Independence Boulevard Area Plan  
Citizen Advisory Group Comment Sheet  
April 2, 2009

## 250' Proposed Right-of-Way from Briar Creek to Harris

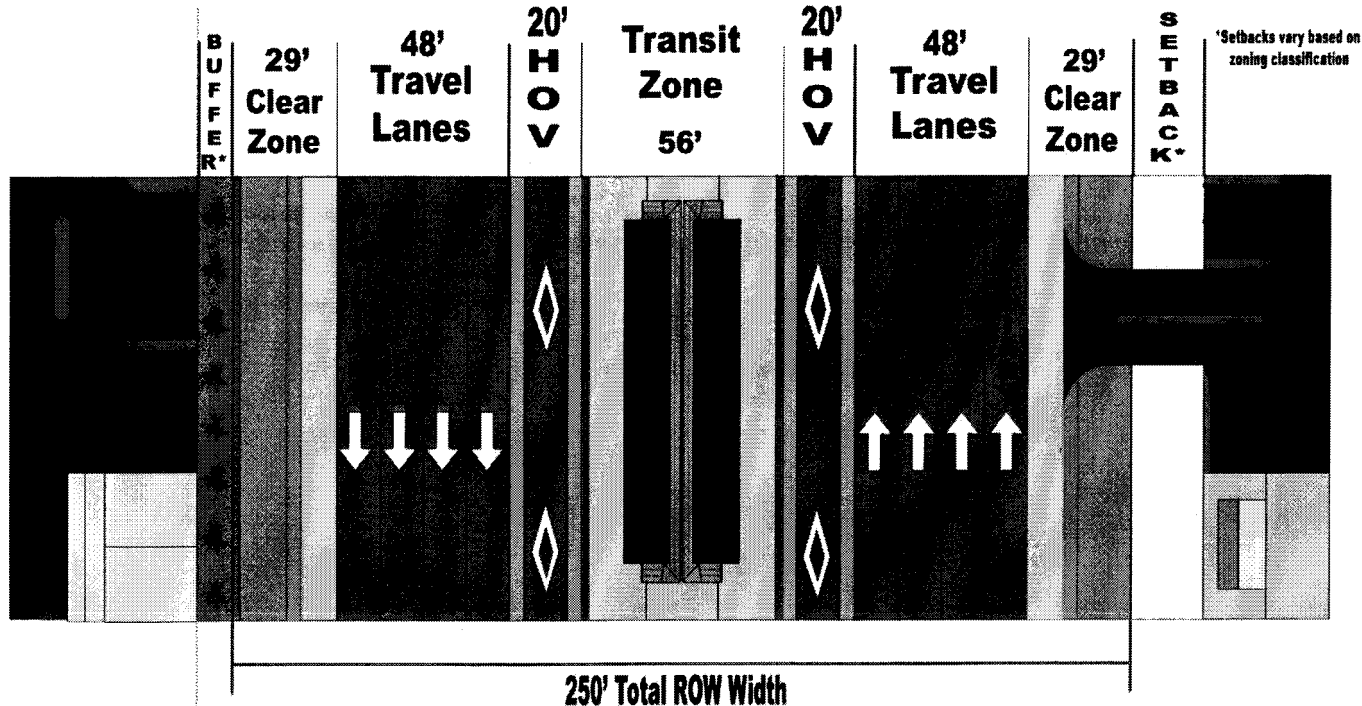
1. Do you think the potential reduction in the proposed right-of-way (ROW) by 100' (existing proposed ROW of 350' to new proposal of 250') will accommodate future transportation needs? Yes ☒ No ☐
2. Do you think the potential reduction in the proposed right-of-way (ROW) by 100' (existing proposed ROW of 350' to new proposal of 250') will accommodate future development needs? Yes ☐ No ☒

*Access still stinks. Without Frontage Road or  
REAL Access, it is all a non-starter*

## 280' Proposed Right-of-Way Beyond Harris Blvd.

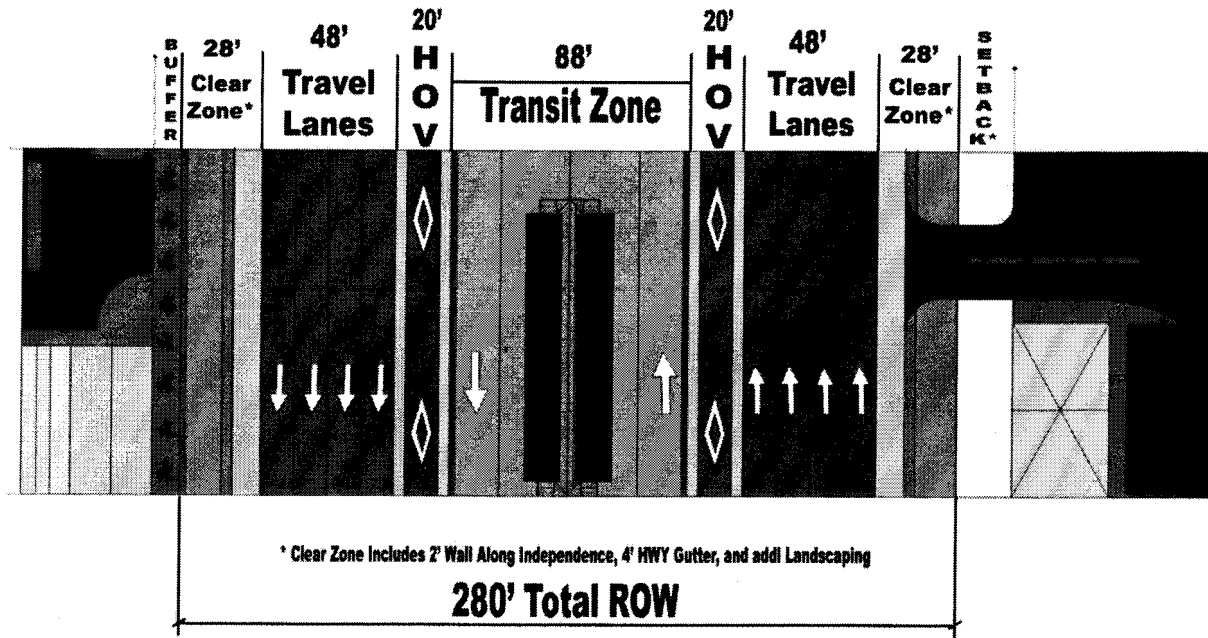
1. Do you think the potential reduction in the proposed right-of-way (ROW) by 70' (existing proposed ROW of 350' to new proposal of 280') will accommodate future transportation needs? Yes X No
2. Do you think the potential reduction in the proposed right-of-way (ROW) by 70' (existing proposed ROW of 350' to new proposal of 280') will accommodate future development needs? Yes        No X

SAME COMMENT AS ON OTHER SIDE

## 250' Proposed Right-of-Way from Briar Creek to Harris

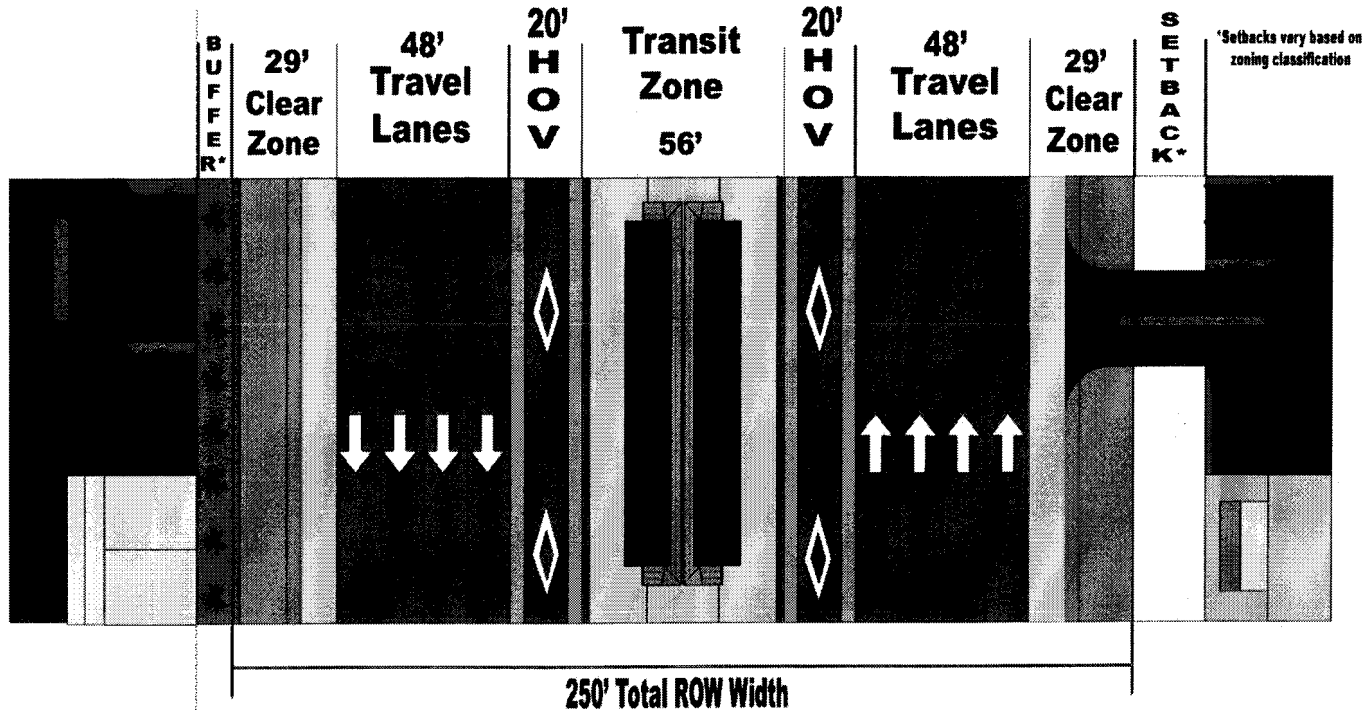
1. Do you think the potential reduction in the proposed right-of-way (ROW) by 100' (existing proposed ROW of 350' to new proposal of 250') will accommodate future transportation needs? Yes ☒ No ☐
2. Do you think the potential reduction in the proposed right-of-way (ROW) by 100' (existing proposed ROW of 350' to new proposal of 250') will accommodate future development needs? Yes ☒ No ☐

Please remove Idlewild Apartments, Ashley and SilverOak to promote business people to come in and build. Those apartment buildings are crime ridden.

## 280' Proposed Right-of-Way Beyond Harris Blvd.

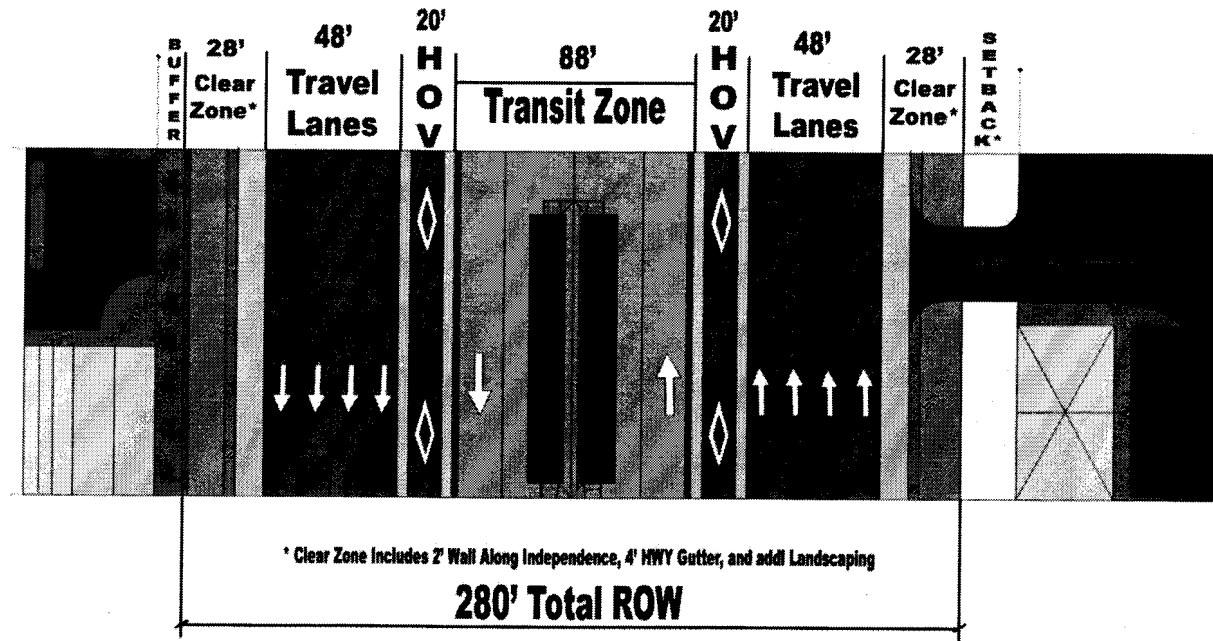
1. Do you think the potential reduction in the proposed right-of-way (ROW) by 70' (existing proposed ROW of 350' to new proposal of 280') will accommodate future transportation needs? Yes ☒ No ☐
2. Do you think the potential reduction in the proposed right-of-way (ROW) by 70' (existing proposed ROW of 350' to new proposal of 280') will accommodate future development needs? Yes ☒ No ☐

You need to address Amity Gardens and Coliseum Shopping Center immediately!!

## 250' Proposed Right-of-Way from Briar Creek to Harris

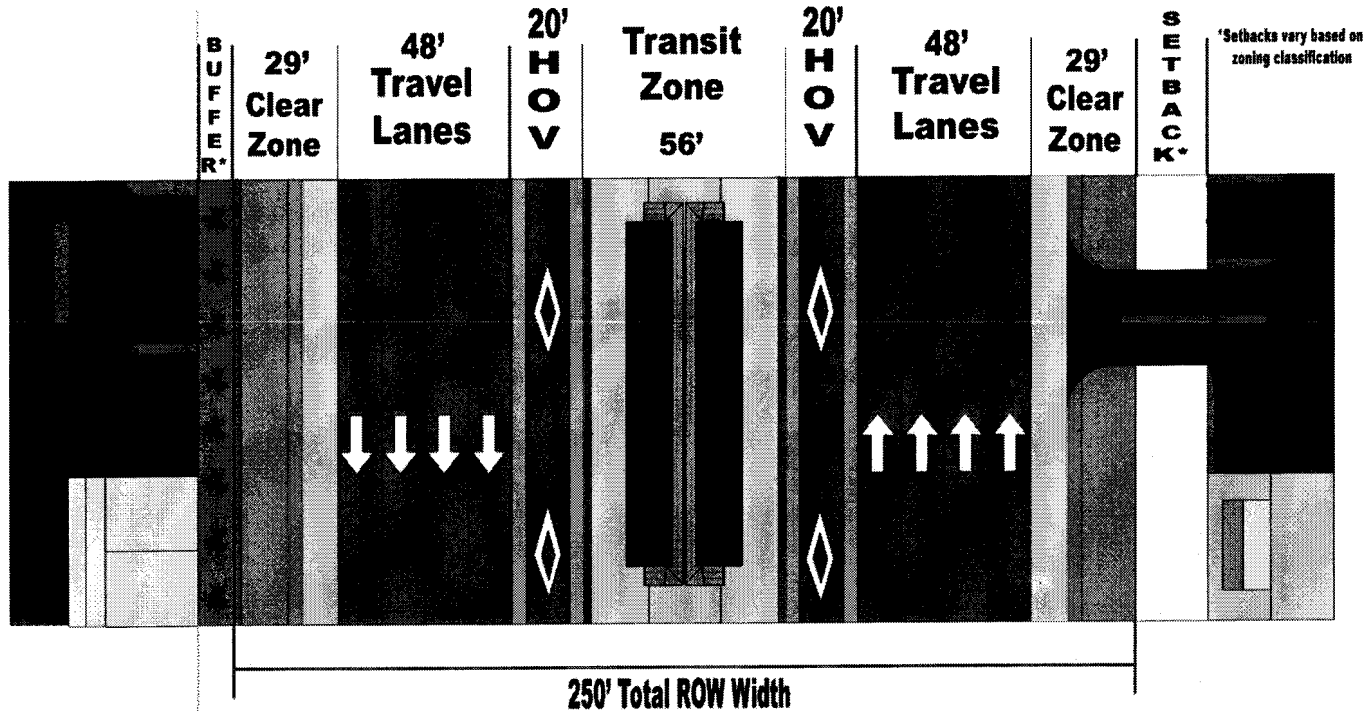
1. Do you think the potential reduction in the proposed right-of-way (ROW) by 100' (existing proposed ROW of 350' to new proposal of 250') will accommodate future transportation needs? Yes ☒ No ☐
2. Do you think the potential reduction in the proposed right-of-way (ROW) by 100' (existing proposed ROW of 350' to new proposal of 250') will accommodate future development needs? Yes ☒ No ☐

Additional Comments: I believe you must start this ASAP.  
The Buffer Internal Land for Green B/L Area park

## 250' Proposed Right-of-Way from Briar Creek to Harris

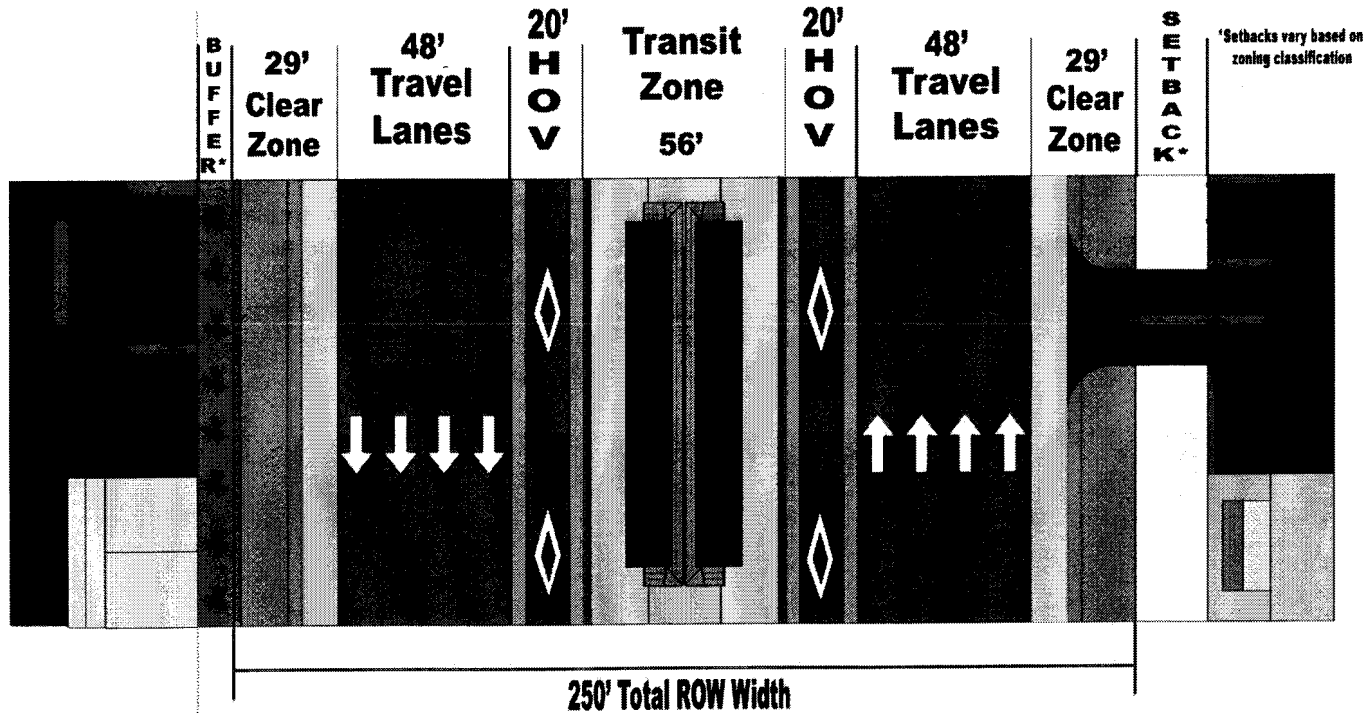
1. Do you think the potential reduction in the proposed right-of-way (ROW) by 100' (existing proposed ROW of 350' to new proposal of 250') will accommodate future transportation needs? Yes ☒ No ☐
2. Do you think the potential reduction in the proposed right-of-way (ROW) by 100' (existing proposed ROW of 350' to new proposal of 250') will accommodate future development needs? Yes ☒ No ☐

Move quickly on Independence -  
Must attract Retail - Remove unsightly, existing  
vacant buildings

## 250' Proposed Right-of-Way from Briar Creek to Harris

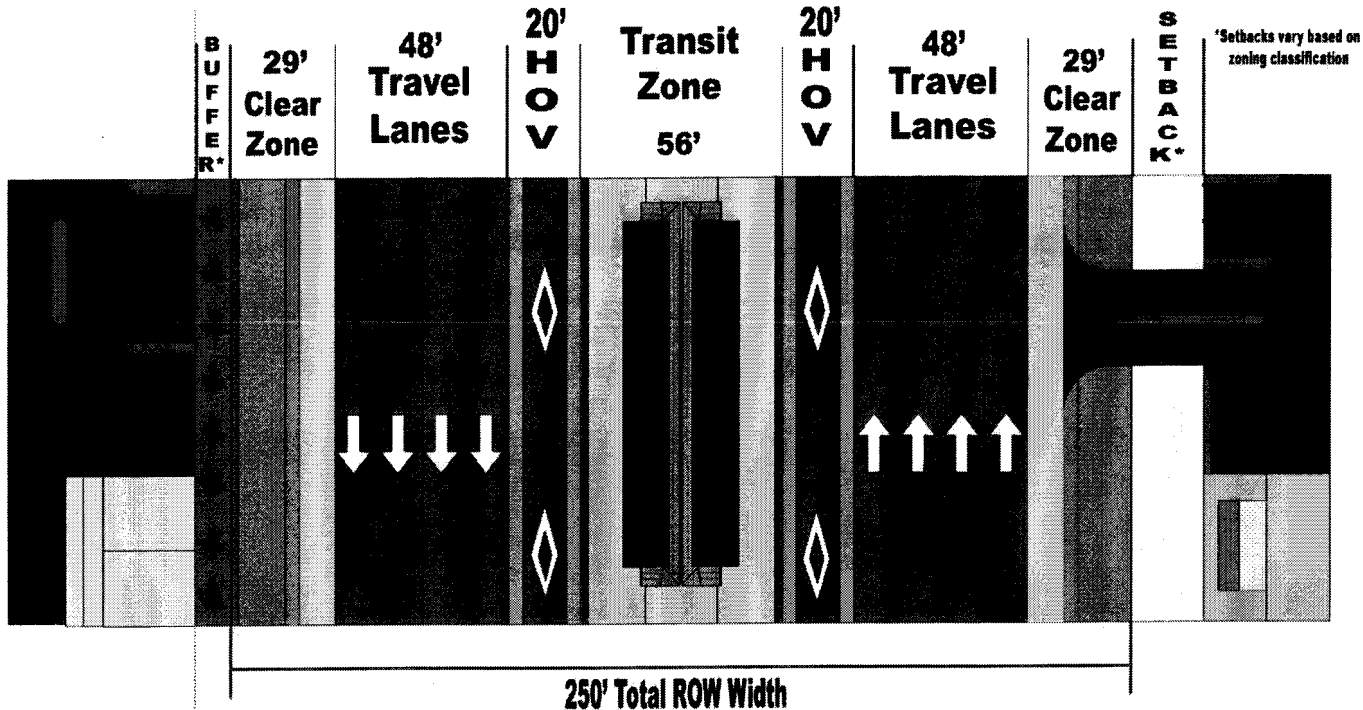
1. Do you think the potential reduction in the proposed right-of-way (ROW) by 100' (existing proposed ROW of 350' to new proposal of 250') will accommodate future transportation needs? Yes ☒ No ☐
2. Do you think the potential reduction in the proposed right-of-way (ROW) by 100' (existing proposed ROW of 350' to new proposal of 250') will accommodate future development needs? Yes ☐ No ☒

I HAVE TO AGREE WITH COMMENTS MADE BY THE GROUP  
1ST DO SOMETHING WITH EMPTY BUILDINGS ALONG INDEP.  
BEFORE PROCEEDING WITH THE DEMOLISHING OF THE NEXT  
PHASE

## 250' Proposed Right-of-Way from Briar Creek to Harris

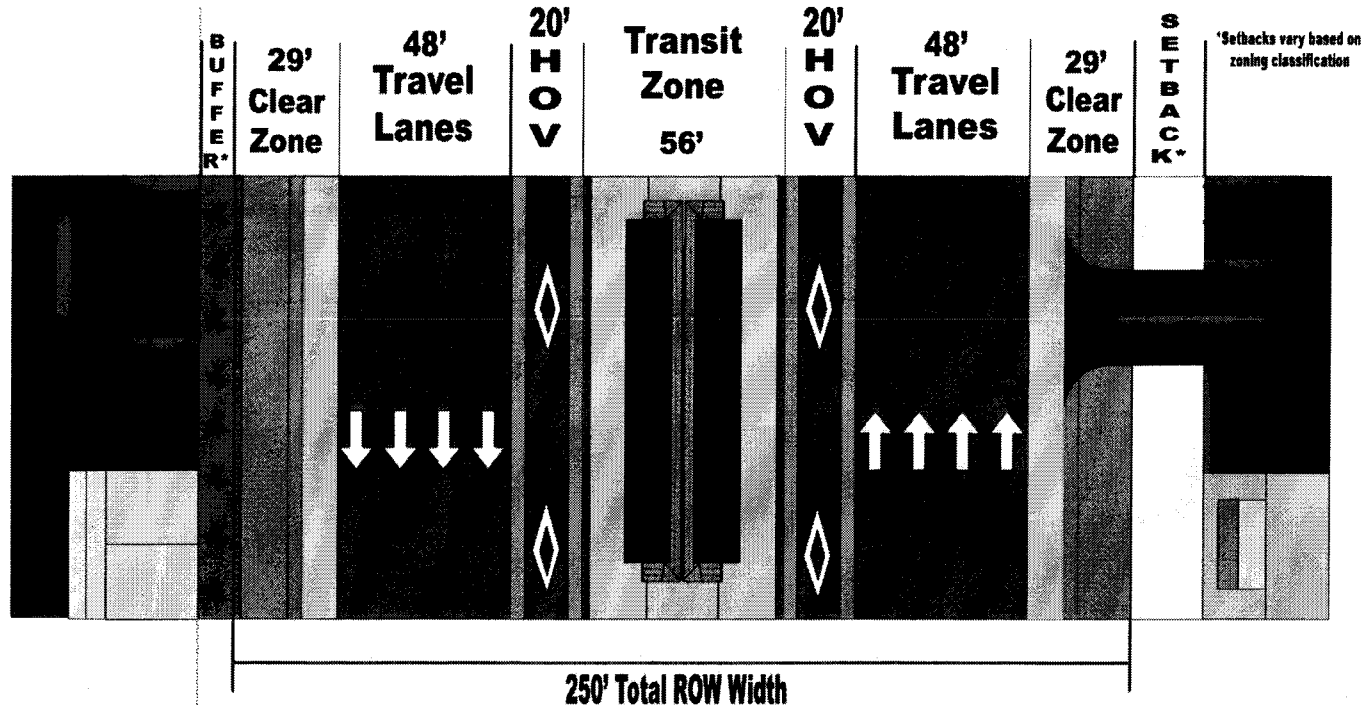
1. Do you think the potential reduction in the proposed right-of-way (ROW) by 100' (existing proposed ROW of 350' to new proposal of 250') will accommodate future transportation needs? Yes ☒ No ☐
2. Do you think the potential reduction in the proposed right-of-way (ROW) by 100' (existing proposed ROW of 350' to new proposal of 250') will accommodate future development needs? Yes ☒ No ☐

to be determined... it sounds good but I am concerned about developers moving ahead when only BCT is promised. Commit to LRT and let the high quality development that this area needs come in.

## 250' Proposed Right-of-Way from Briar Creek to Harris

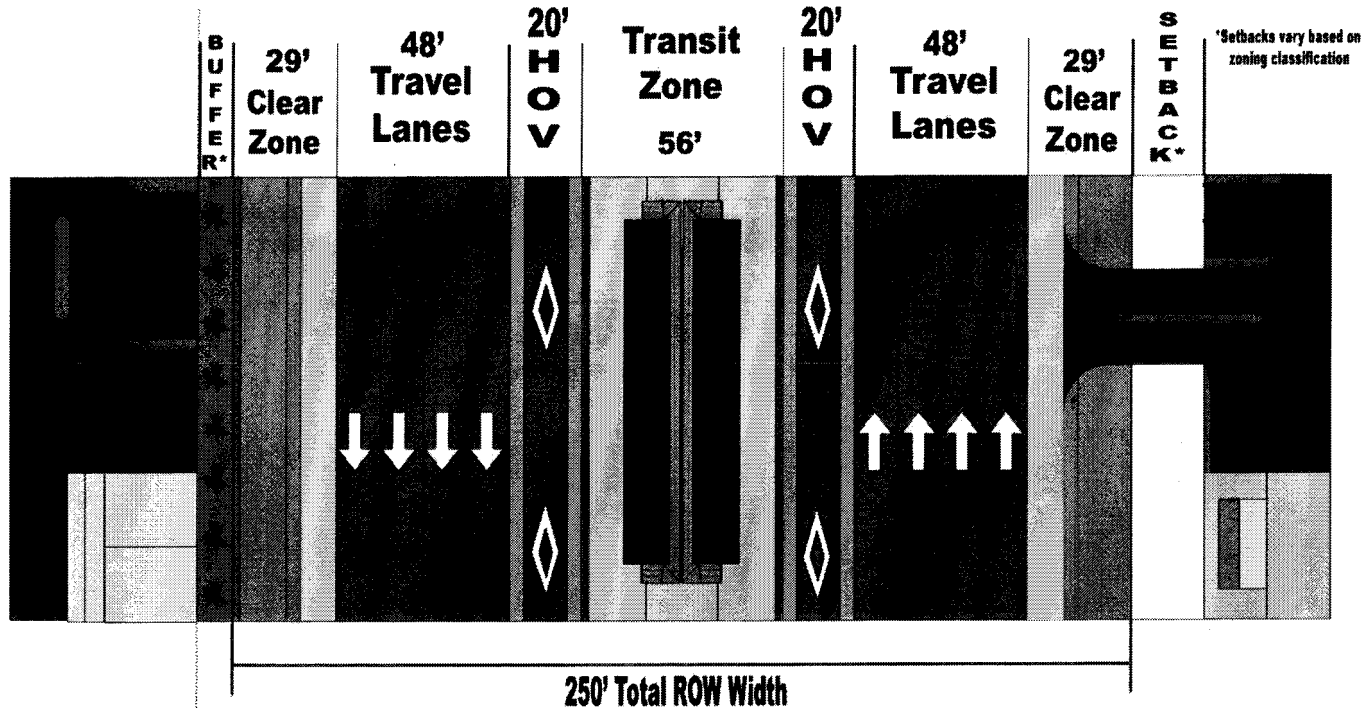
*Buy business & land off on north side of Independence so the businesses can relocate*

## 250' Proposed Right-of-Way from Briar Creek to Harris

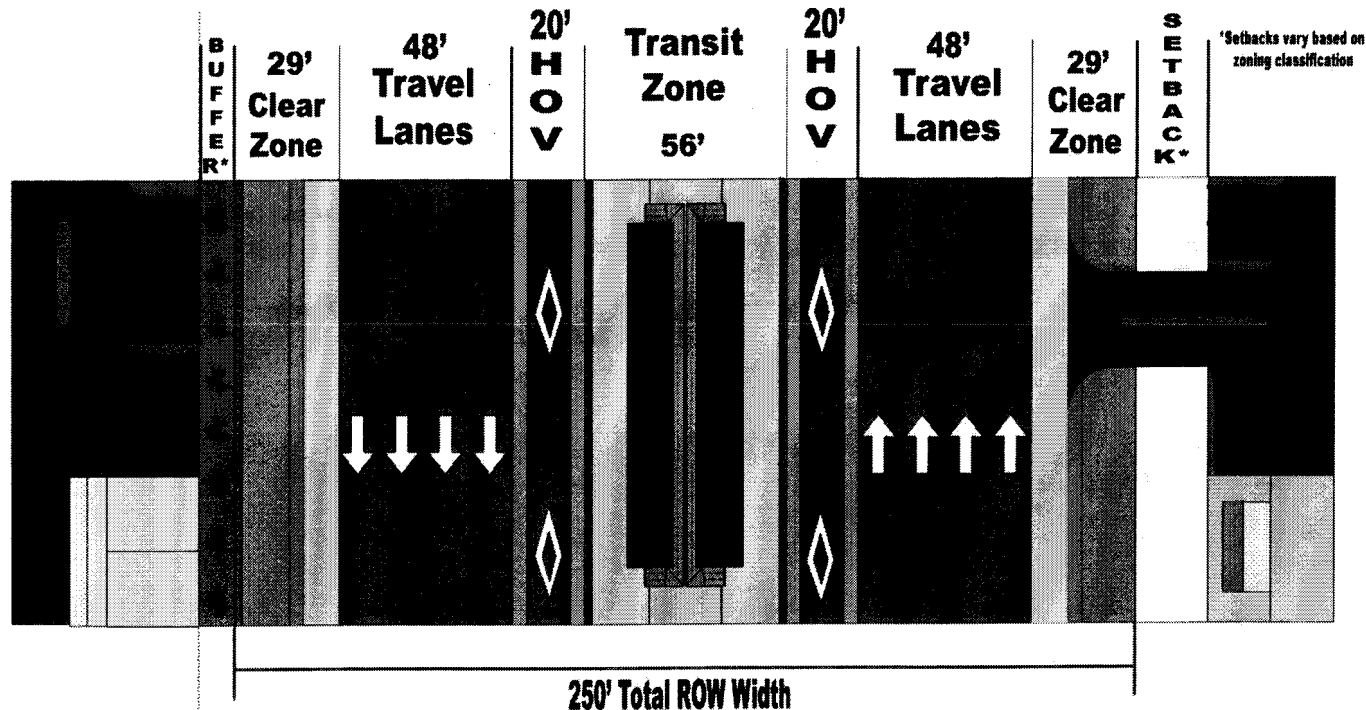
1. Do you think the potential reduction in the proposed right-of-way (ROW) by 100' (existing proposed ROW of 350' to new proposal of 250') will accommodate future transportation needs? Yes ☒ No ☐
2. Do you think the potential reduction in the proposed right-of-way (ROW) by 100' (existing proposed ROW of 350' to new proposal of 250') will accommodate future development needs? Yes ☒ No ☐

*This helps more but access will always be a problem and the value of the real estate will continue to diminish.*

## 280' Proposed Right-of-Way Beyond Harris Blvd.

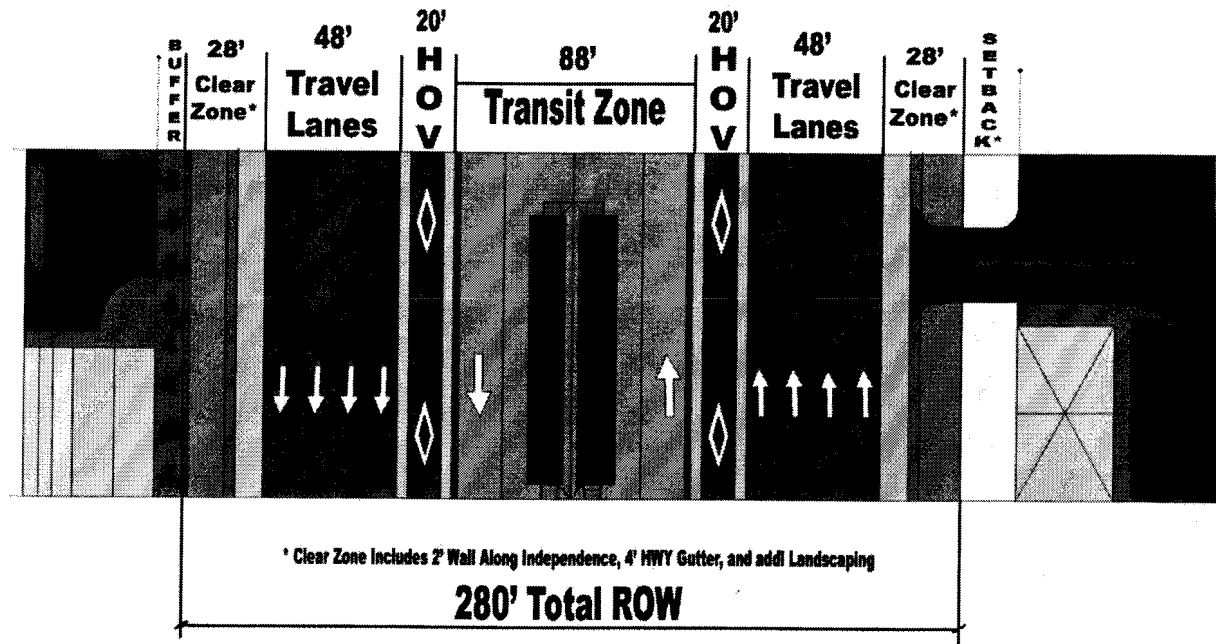
1. Do you think the potential reduction in the proposed right-of-way (ROW) by 70' (existing proposed ROW of 350' to new proposal of 280') will accommodate future transportation needs? Yes \_\_\_\_\_ No ✓
2. Do you think the potential reduction in the proposed right-of-way (ROW) by 70' (existing proposed ROW of 350' to new proposal of 280') will accommodate future development needs? Yes \_\_\_\_\_ No ✓

Access is still an issue for business owners.
